STATE OF WASHINGTON
DEPARTMENT OF ECOLOGY

March 07, 2024

Re: Ecology Comments on Draft Agreed Order Remedial Investigation Work Plan
TECT Aerospace Everett
2933 109th St SW, Everett, WA 98204
Facility Site No.: 17392
Cleanup Site ID No.: 12071

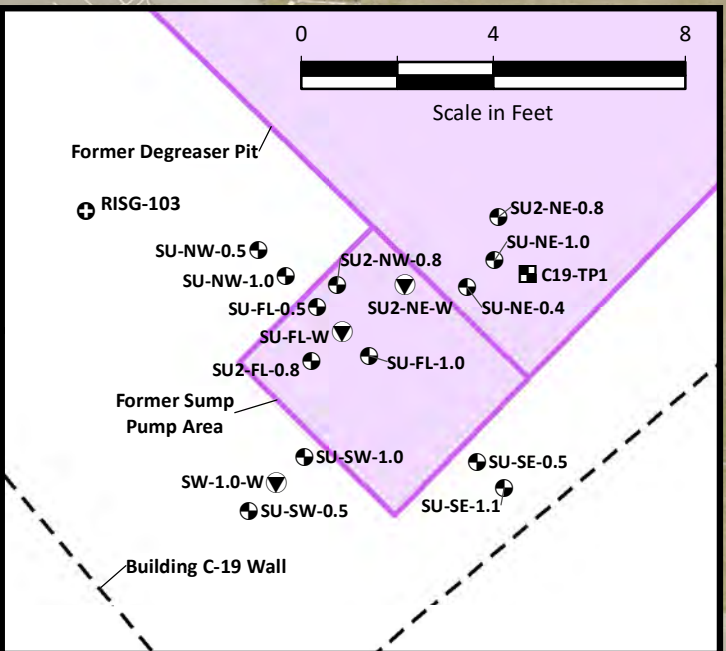
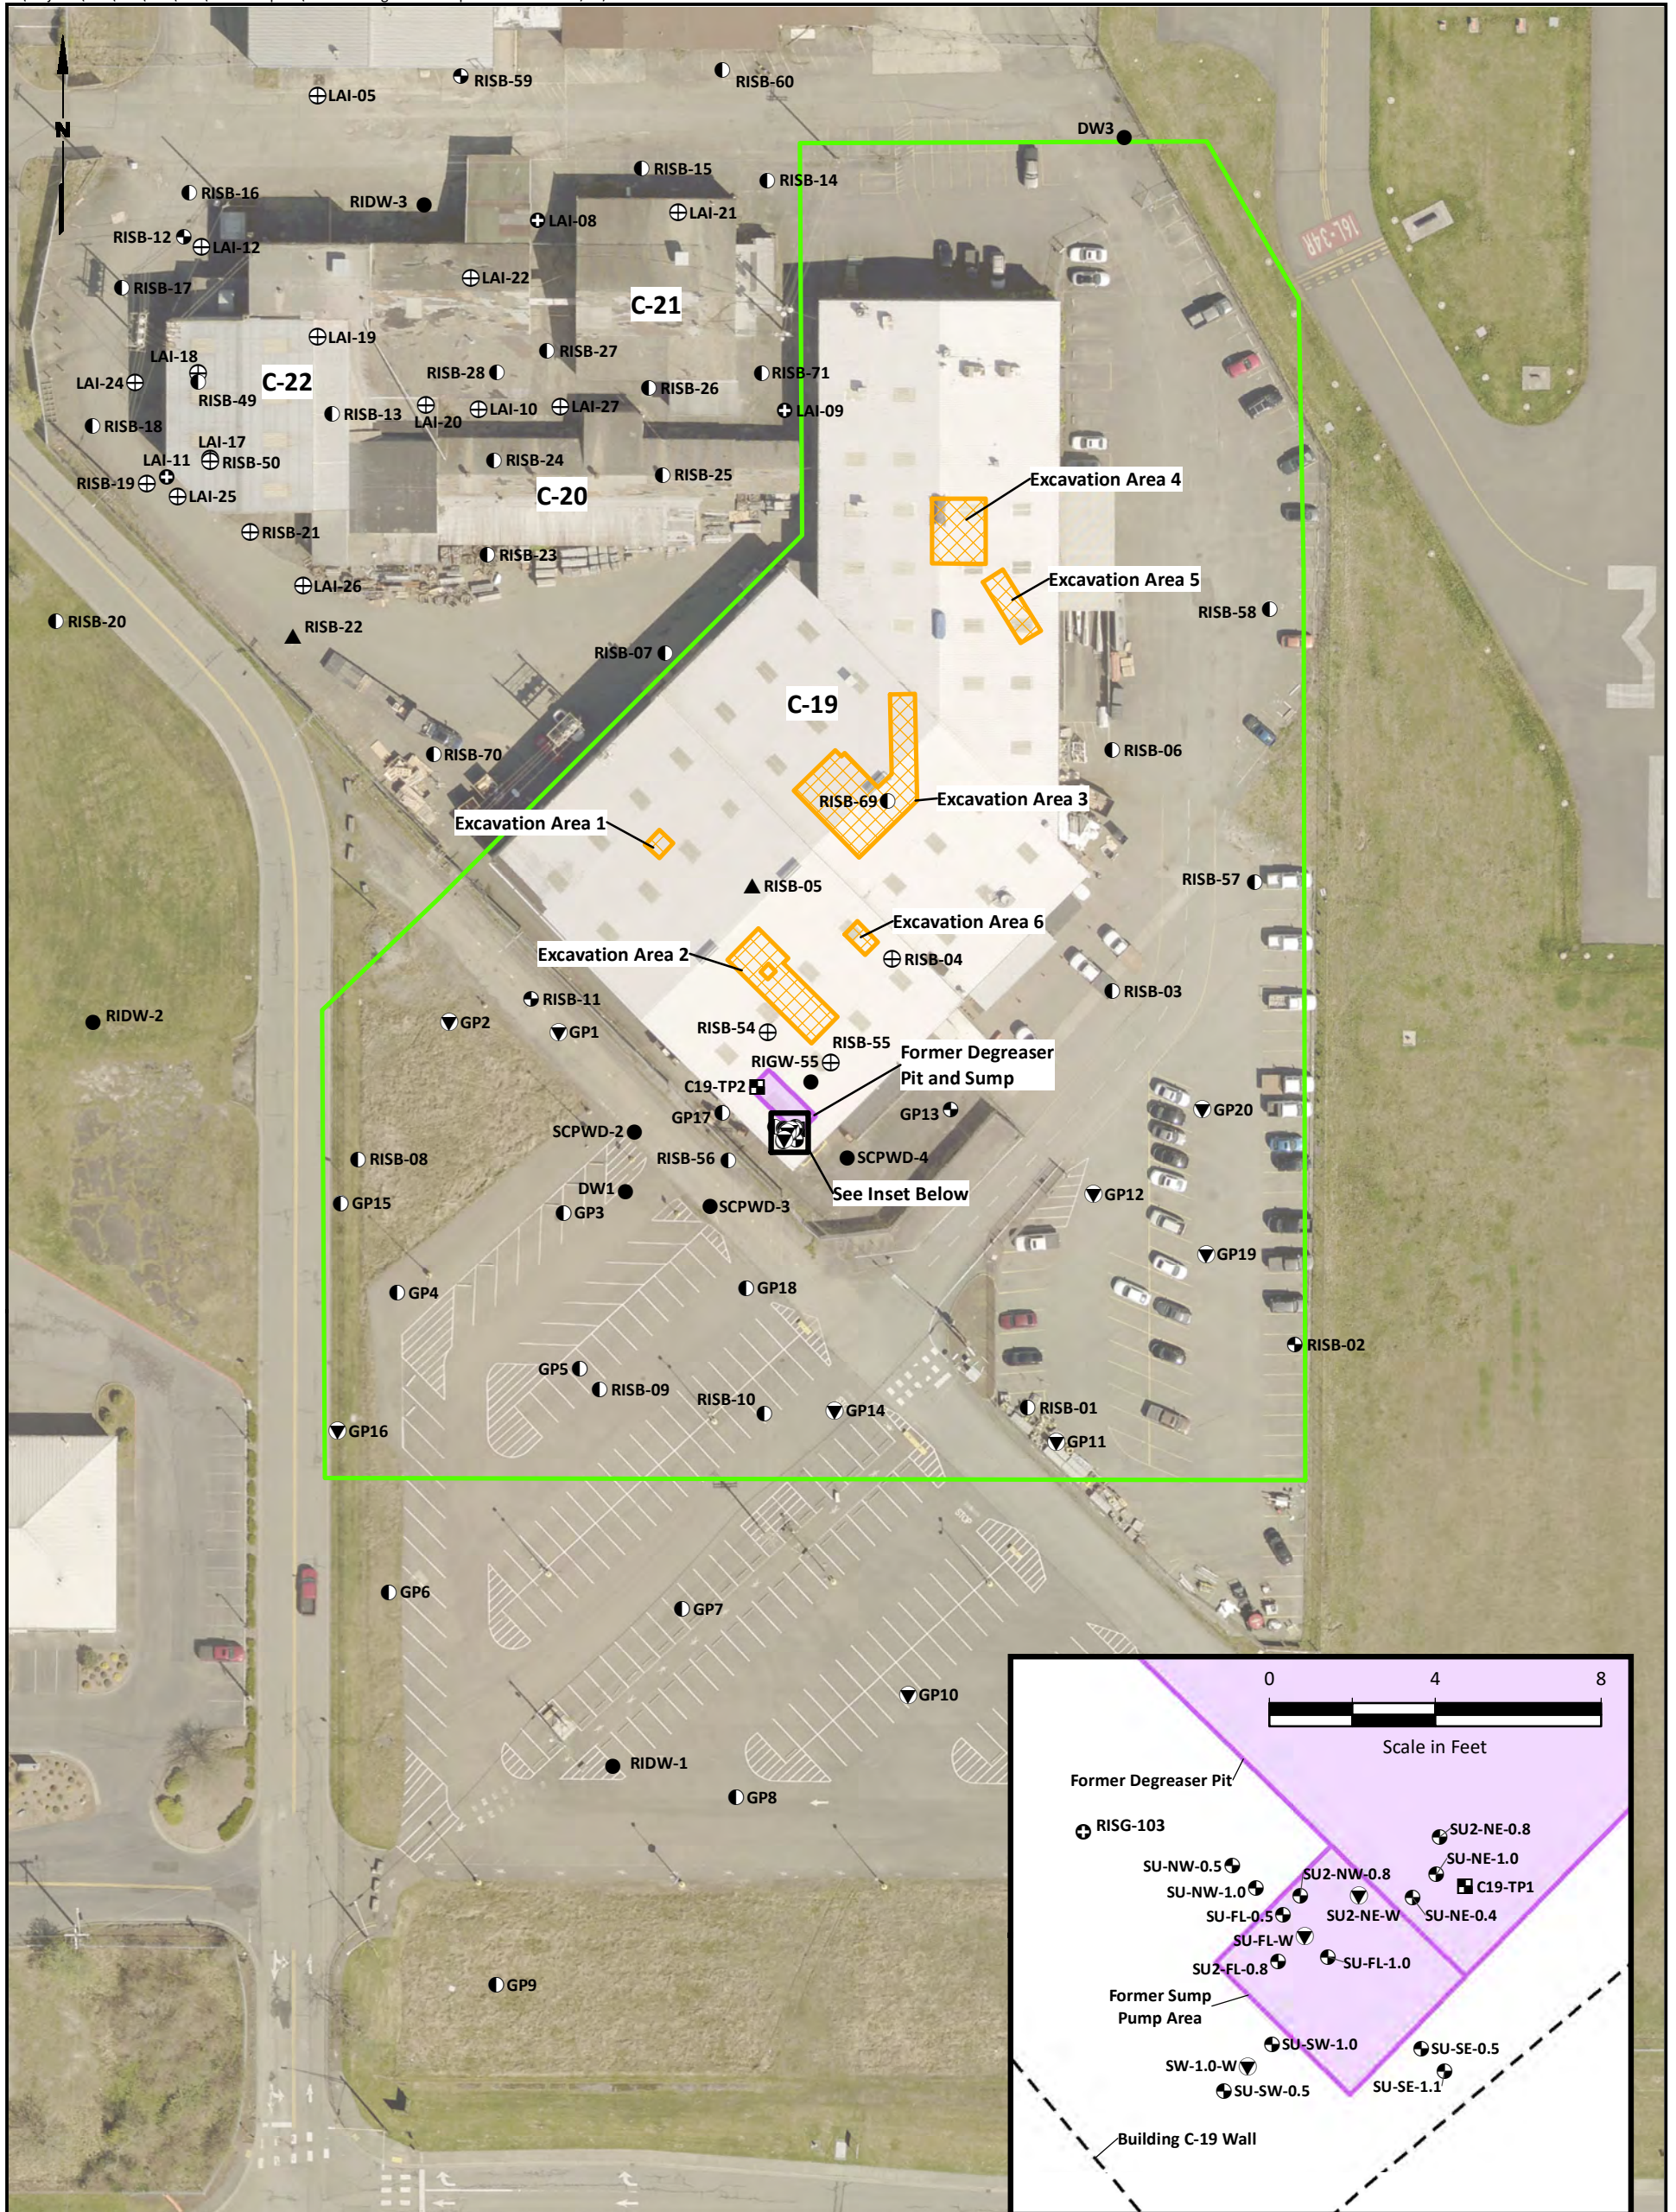
- **Building C-20 to -22 Area:**

- A shallow soil sample collected from 1-2 feet below ground surface (bgs) from RISB-22 in 2019 contained diesel- (TPH-D) and oil-range (TPH-O) total petroleum hydrocarbons above the screening levels established in the *December 2023 Draft AO RIWP*. Ecology requires collecting soil samples for analysis of from RISG-204 and -205 to characterize the extent of soil contamination in this area.

- The speciation of chromium (Cr) in soil and groundwater at the Site is a data gap. The *December 2023 Draft AO RIWP* includes the collection of a groundwater sample from proposed monitoring well RIGW-100 for speciation of Cr in groundwater. Soil samples collected from RISB-13 from 10 to 13 feet bgs from in 2019 contained total Cr above the screening level for Cr VI. Ecology requests soil samples be collected for speciation of Cr in soil from RIGW-100.

- The *December 2023 Draft AO RIWP* includes a survey of a trench drain inside Building C-22 to identify the discharge point of the drain. Ecology requires discussion of the collection of additional soil and/or groundwater for Site COCs at the discharge point of the drain depending on how the drain terminates.

- Groundwater samples collected from RISB-07, RISB-13, RISB-23 through RISB-25 and RISB-49 contained TPH-D and TPH-O above the established screening levels. Historical groundwater samples collected south of building C-22 and east of building C-21 were not analyzed for TPH-D and TPH-O. Additional groundwater samples are needed east of RISB-14 and RISB-60, and south of RISB-07, RISB-23, and RISB-49 to delineate exceedances of TPH-D+O and volatile organic compounds (VOCs) in this area. Ecology requests at least one boring in both these areas be completed as a permanent monitoring well in order to aid in long-term site-wide shallow groundwater characterization.

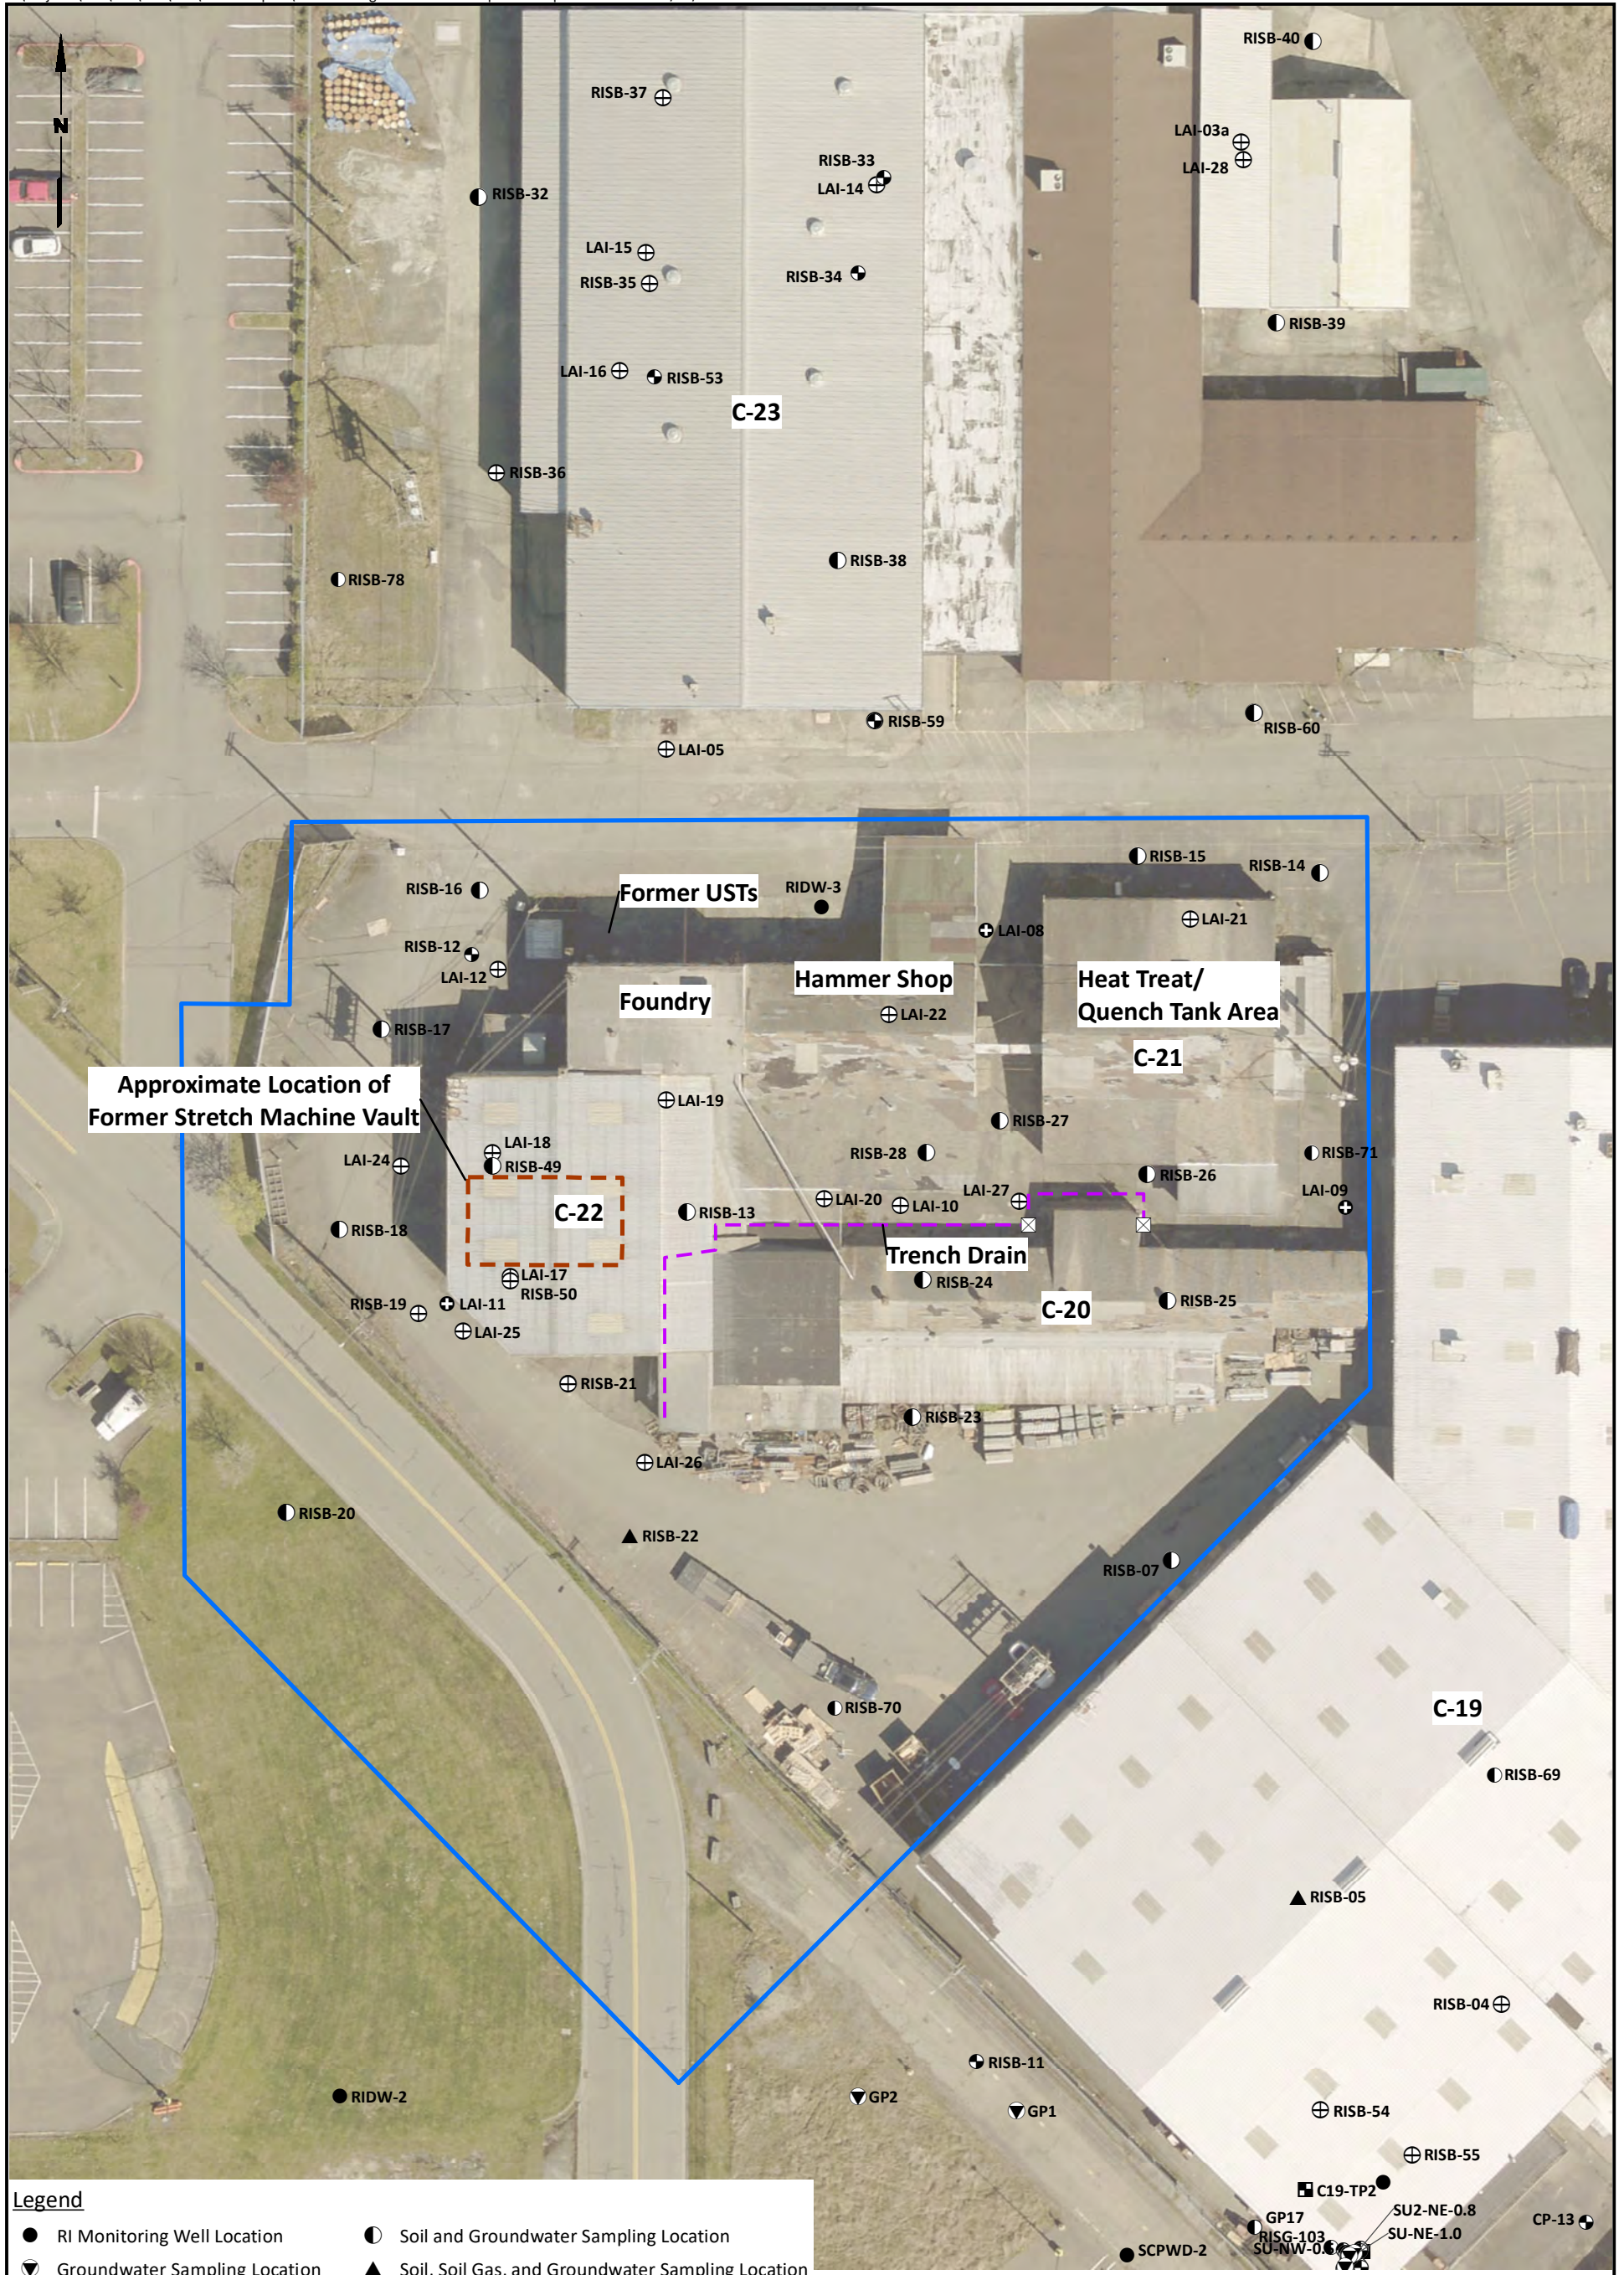
- **Building C-23 Area**
 - Soil and groundwater samples collected from RISB-61 contained cis-1,2-dichloroethene (DCE) and vinyl chloride, respectively, above the Site screening levels. Ecology requests additional borings east of RISB-61 to delineate the extent of contamination in this area.
